**APPLICATION NO:** 22/04720/FUL

**DESCRIPTION:** Construction of a floodlit, recyclable all-weather turf pitch and Multi-Use Games Area (MUGA), and additional lighting to the existing training strip

**LOCATION:** Eastern Sports Field, Sports Training Village, University of Bath Campus, Claverton Down, Bath

## **ANNEX 1. COTSWOLDS NATIONAL LANDSCAPE CONSULTATION RESPONSE IN RELATION TO PLANNING APPLICATION 22/04720/FUL**

## APPENDIX 1. DISTANCE FROM WHICH THE PROPOSED DEVELOPMENT COULD POTENTIALLY BE SEEN

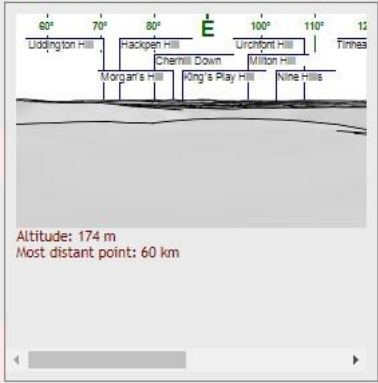
The information presented below uses visual panorama software from the Ulrich Deuschle website ([https://udeuschle.de/panoramas/makepanoramas\\_en.htm](https://udeuschle.de/panoramas/makepanoramas_en.htm)). This indicates that east-facing flood lighting, 18m above ground level in this location could, theoretically, be seen from up to approximately 60km away
